# Technical Service Information

## FORD AXOD-E PREMATURE PLANETARY FAILURE

Figure 1

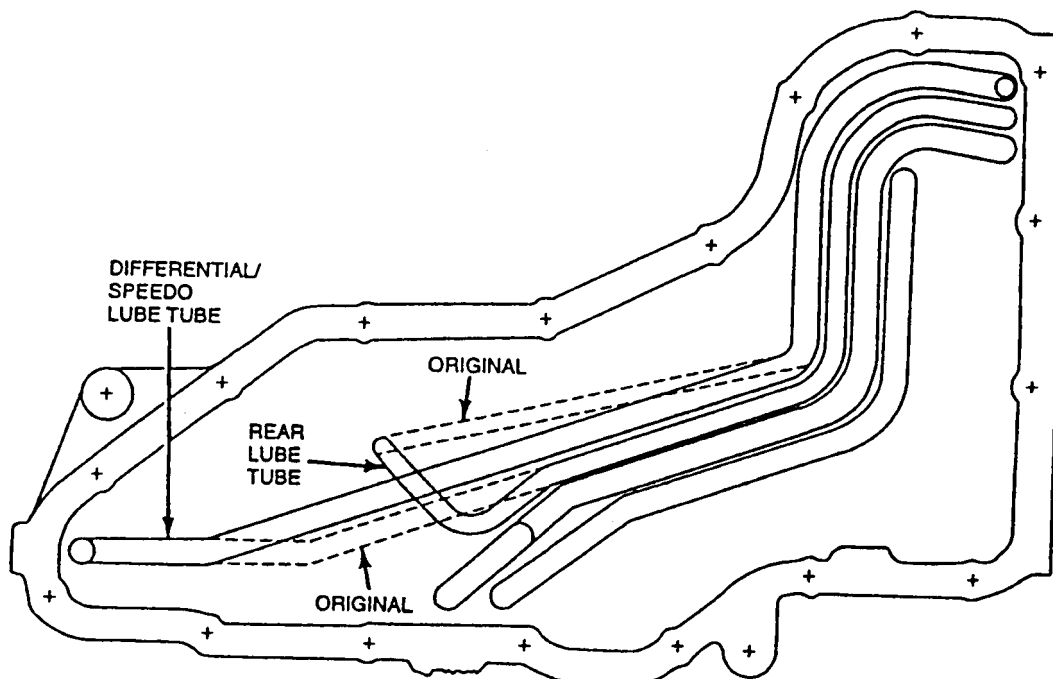
**COMPLAINT:** Front planetary and gear train failure with no visible reason.

**CAUSE:** The cause may be, a limited volume of lube oil to the front planetary due to hydraulic control system demands.

**CORRECTION:** Install a new crossover rear lube tube, OEM number F2DZ-7G084-A, and a new differential/speed0 lube tube, OEM number F2DZ-7G086-A, that will increase the volume of lube to the front planetary. The rear lube tube and the differential/speed0 lube tube, Figure 1, have been reversed in the transaxle case. This requires the rear lube tube to "Cross-Over" the differential/speed0 lube tube. This crossover will allow for a larger volume of uninterrupted lube to the front planetary.  
This change has been incorporated in mid-year 1992 for ALL AXOD-E transaxles.
